ADDENDUM NO. 1

DEERFIELD
Federal Aid Project No. BFL(BR-OFF)-0032(052)X
Bridge Replacement, D-06-001,
Upper Road Over Deerfield River

Transmitting revisions to the Contract Documents as follows:

Revised Plan Sheets 47, 49, 50, 51, 52, 61 & 63 of 92.

STAGE 1 CONSTRUCTION PLAN AND SECTION 1 OF 2

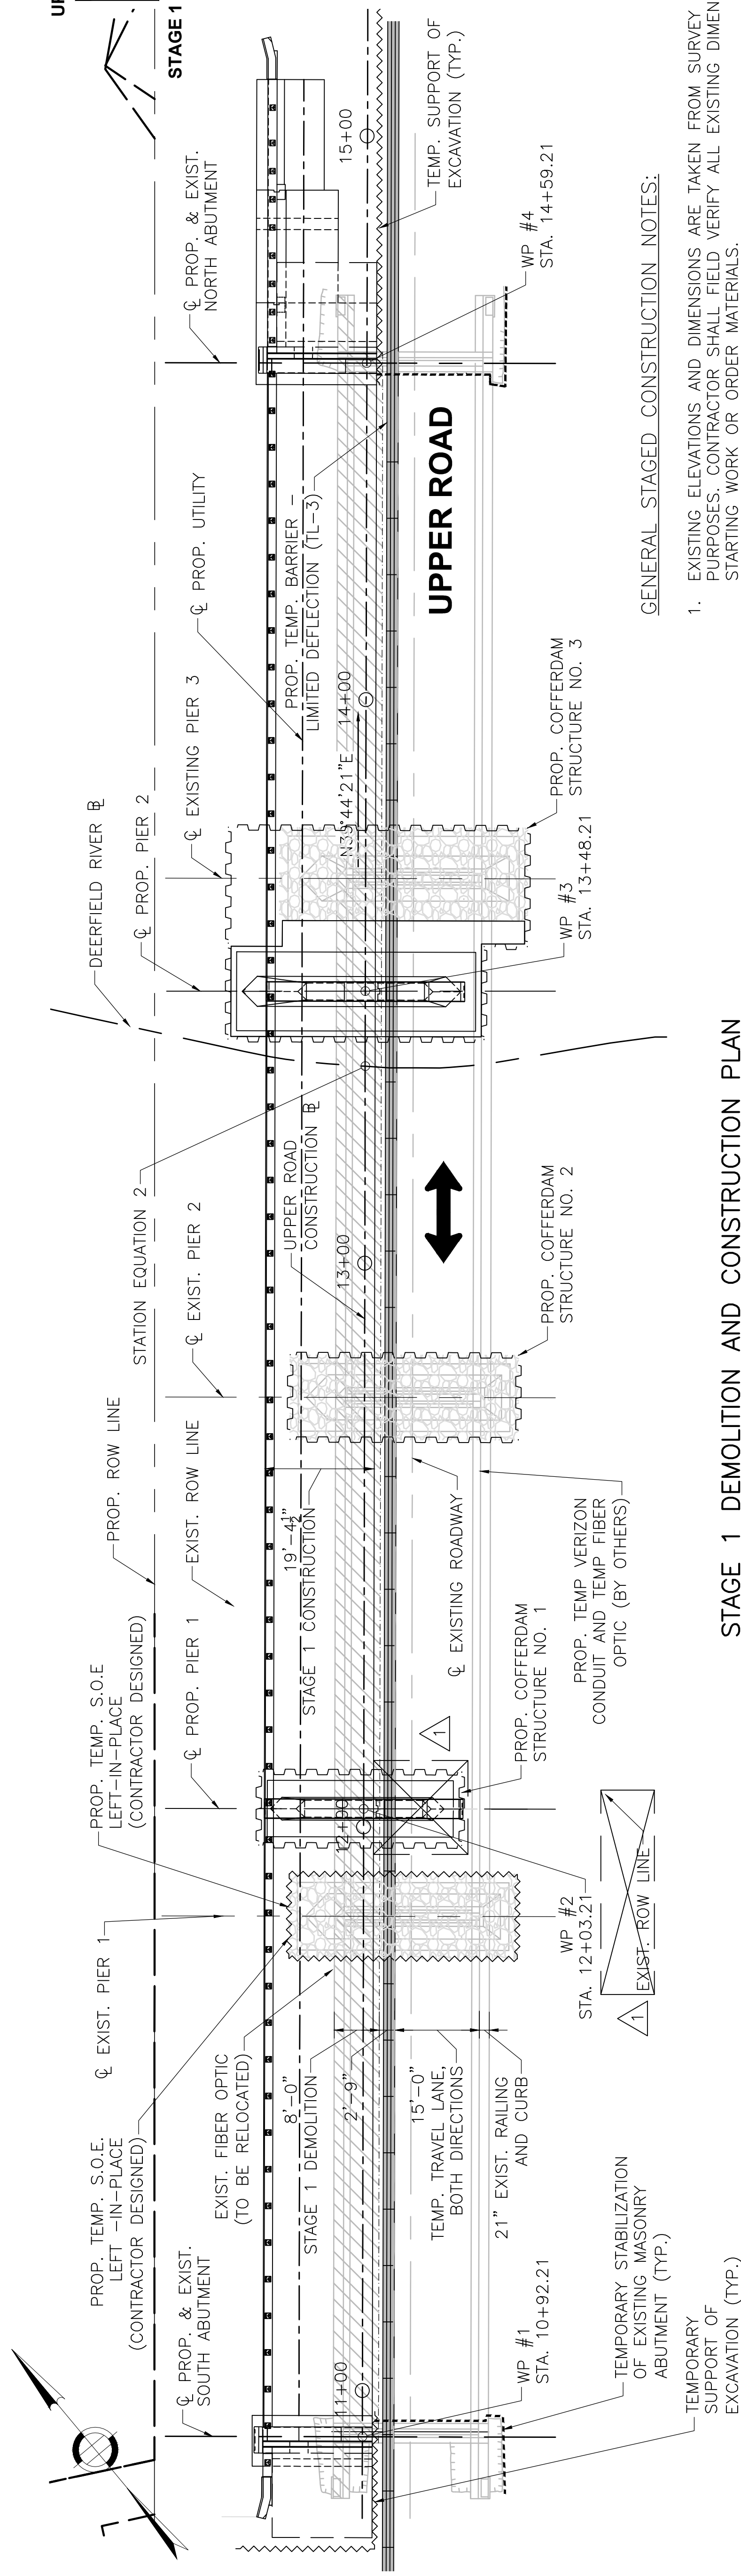
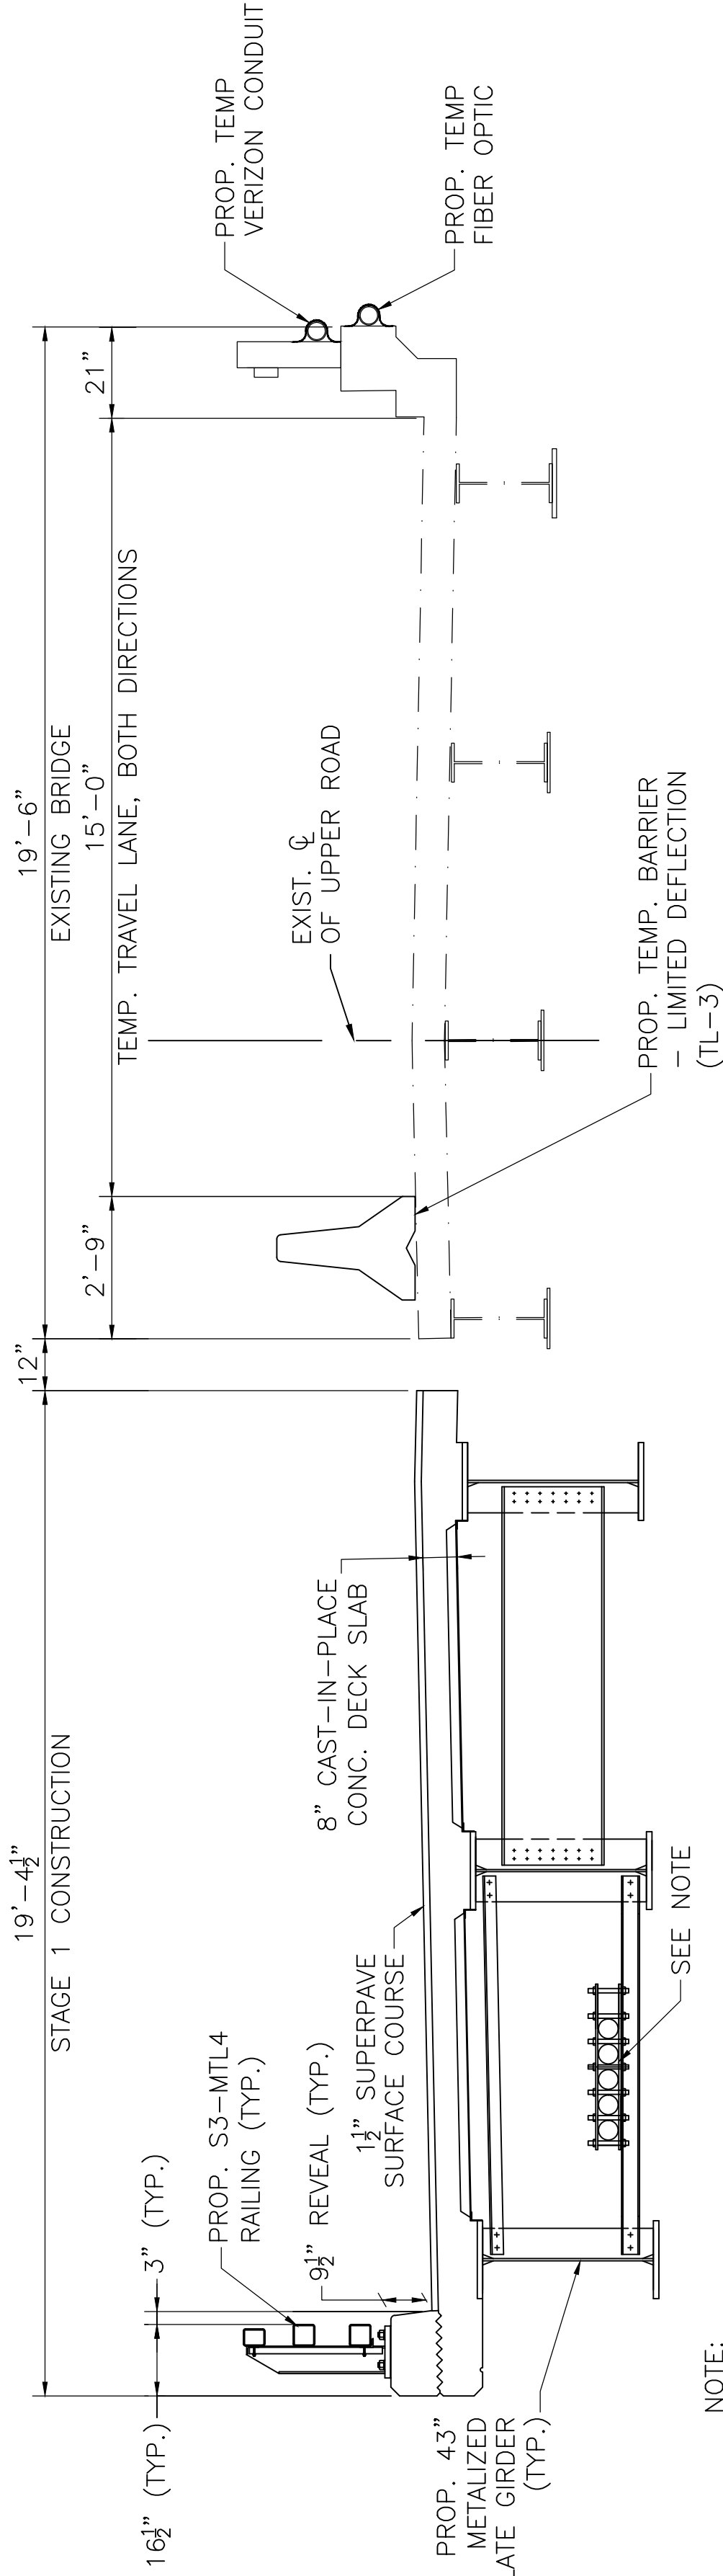
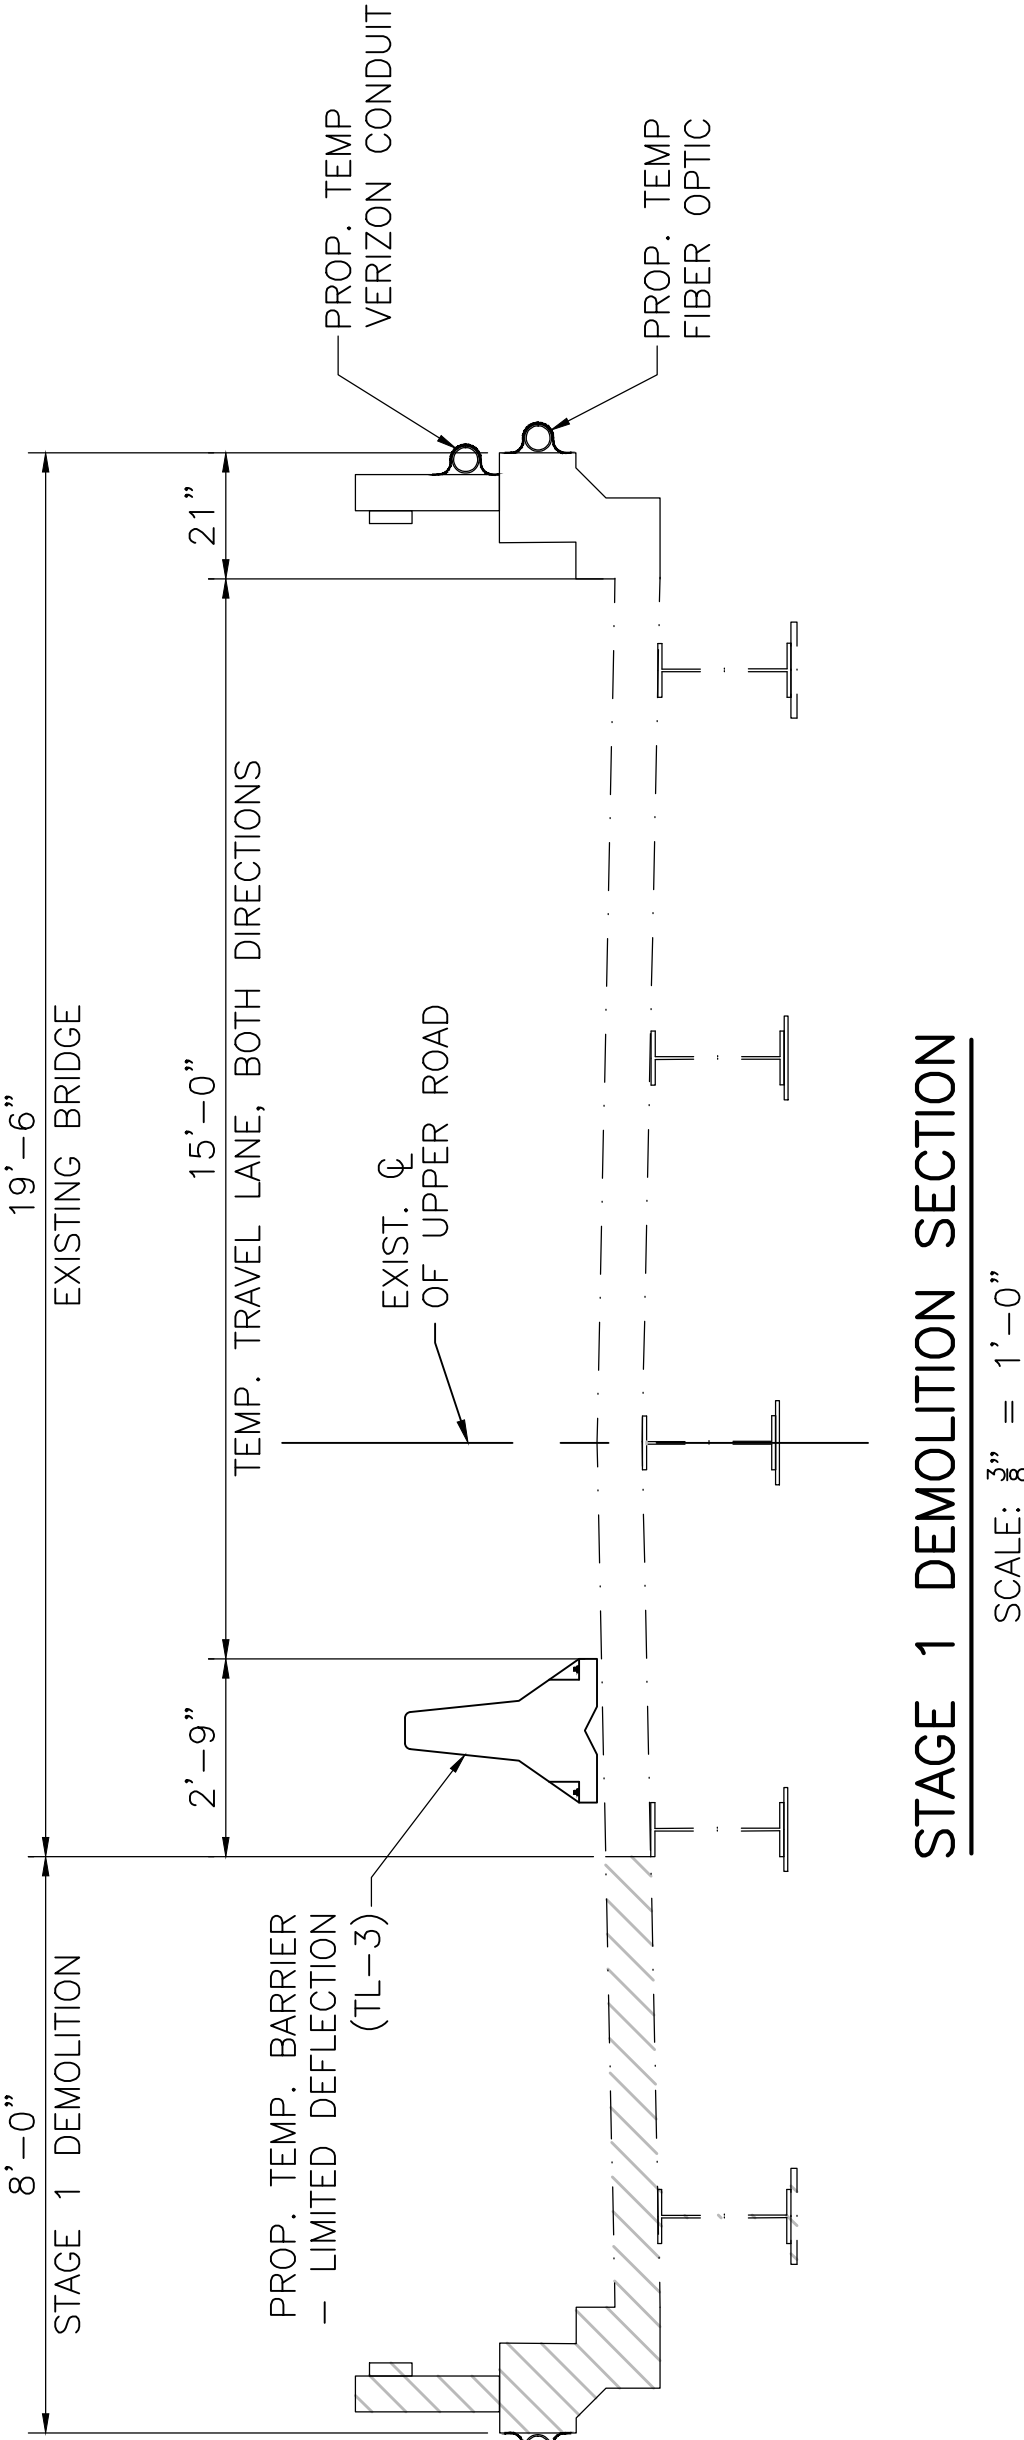
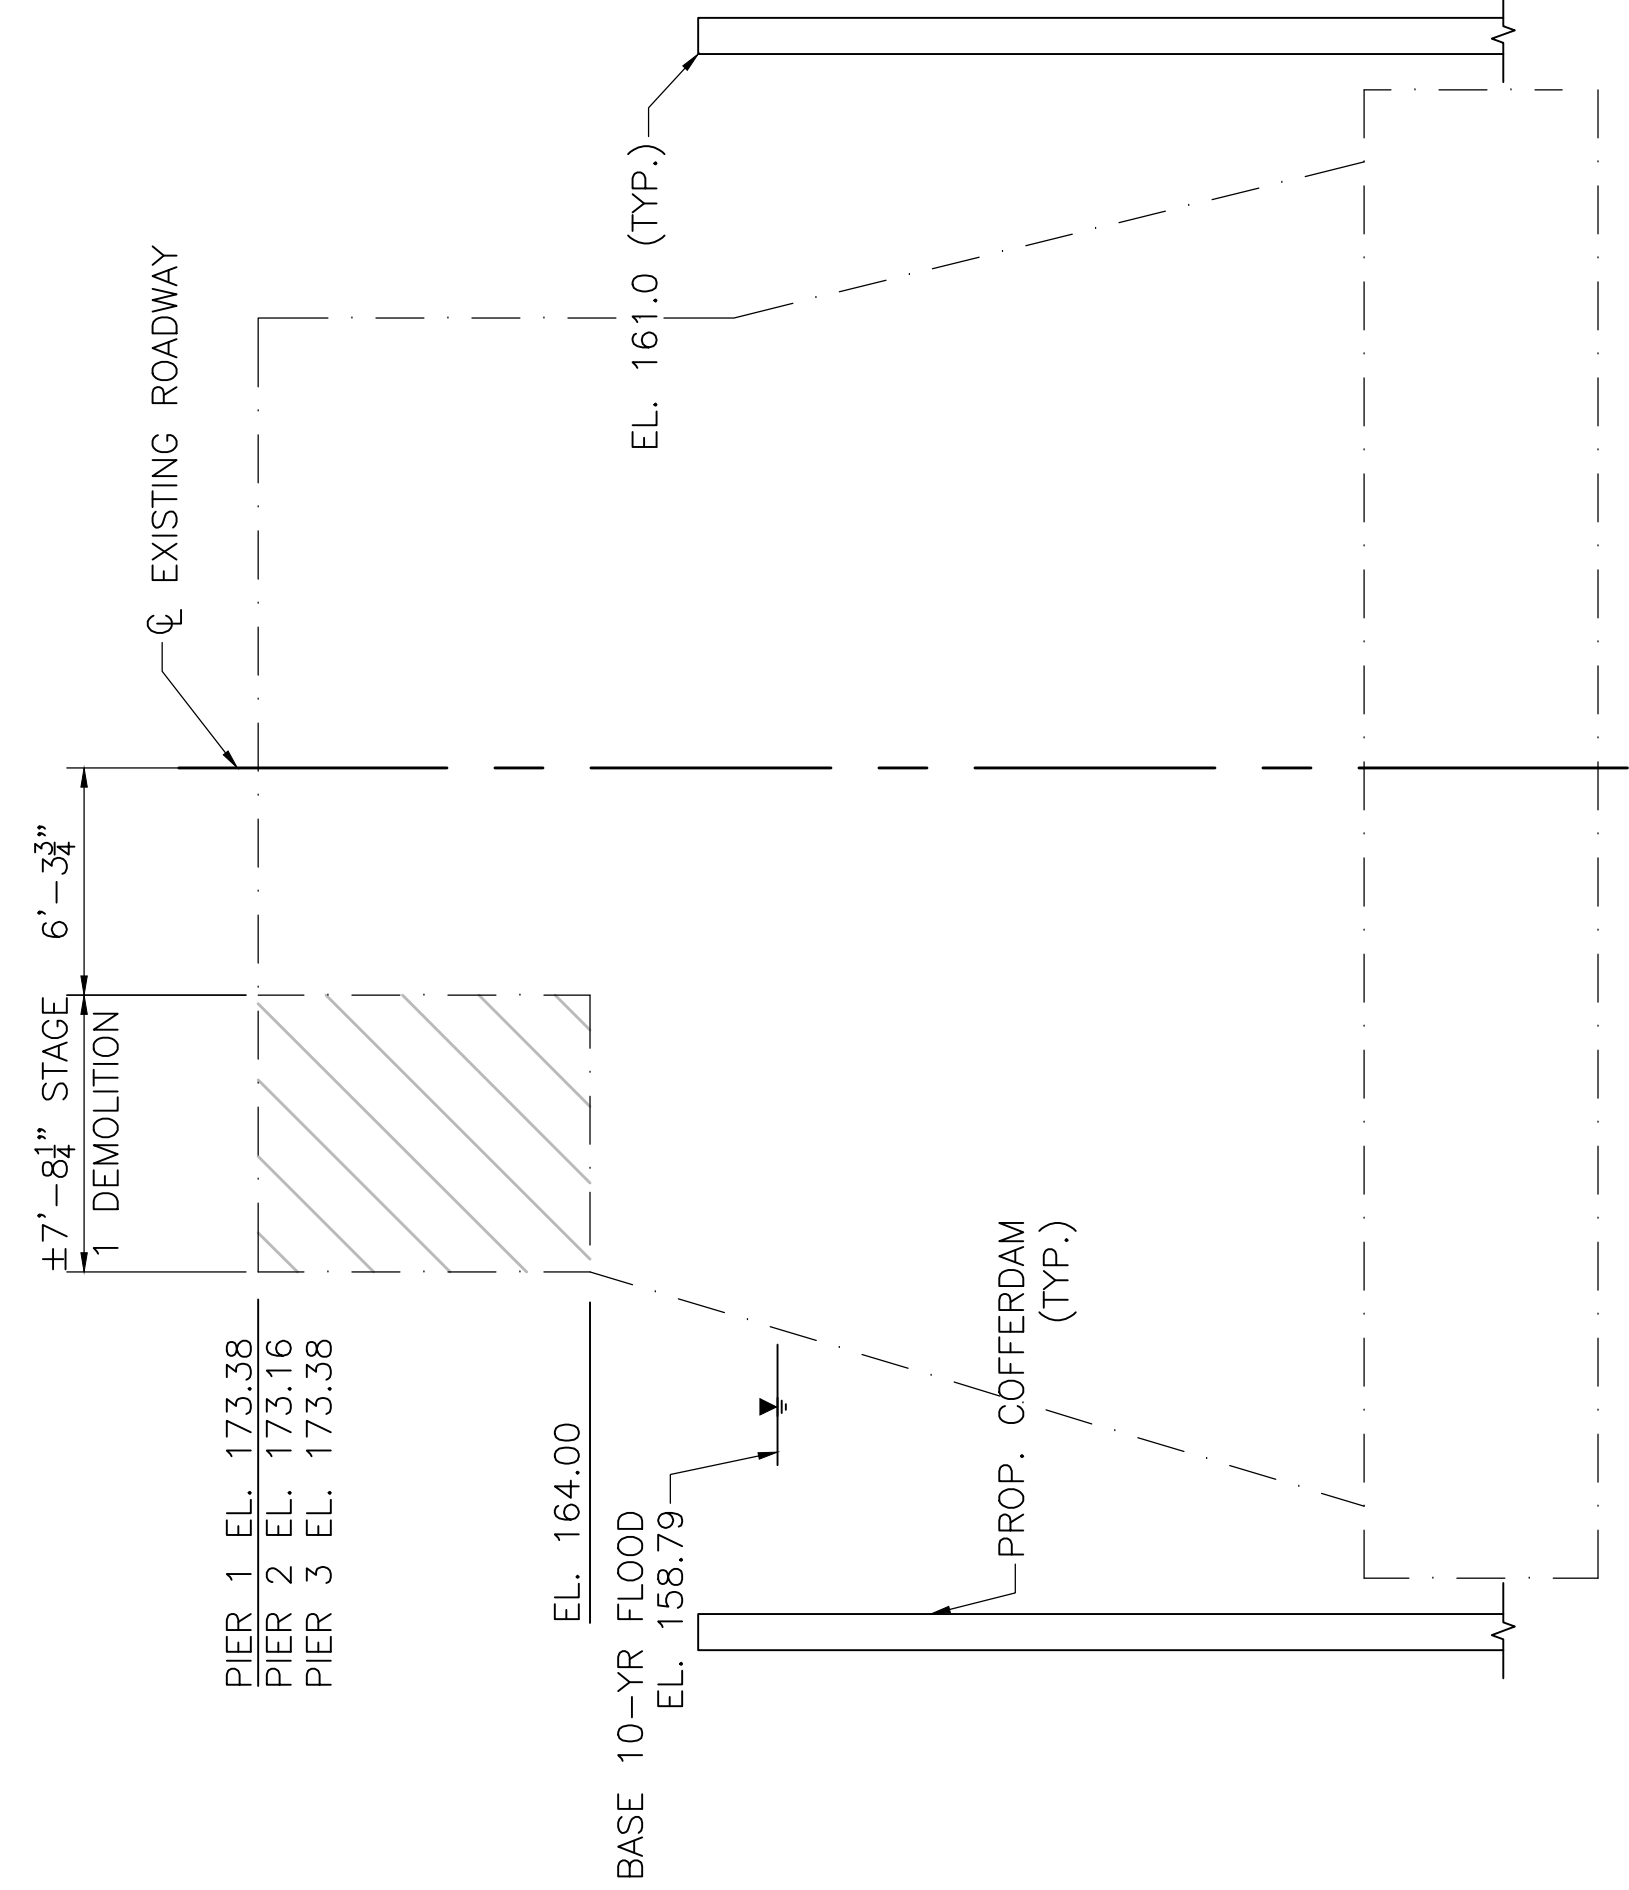
The proposed Pier 1 shows 24 H-piles driven to a tip elevation of 61.5, each pile with a length in excess of 85 feet. All 24 piles are shown to be installed in Stage 1, and it appears that approximately half of these piles are shown to be installed under the remaining portion of the existing bridge deck (Bridge Drawings, Sheet 13 of 41 Sheets). If this is the intent, then the piles to be installed with limited overhead room may not be able to be installed in accordance with the Standard Specifications for Subsection 940: Driven Piles, in regards to pile lengths, use of fixed leads on a crane, etc.

Can Pier 1 be installed and built with construction joints in the footing and stem for the phased construction approach, like what is shown for construction joints in the south abutment?

1 SEE REVISED DETAIL, THIS SHEET.

See revised Plan Sheets 47 of 92 (11 of 41), 49 of 92 (13 of 41), 50 of 92 (14 of 41), 52 of 92 (16 of 41), 61 of 92 (25 of 41), and 63 of 92 (27 of 41) issued via this addendum.
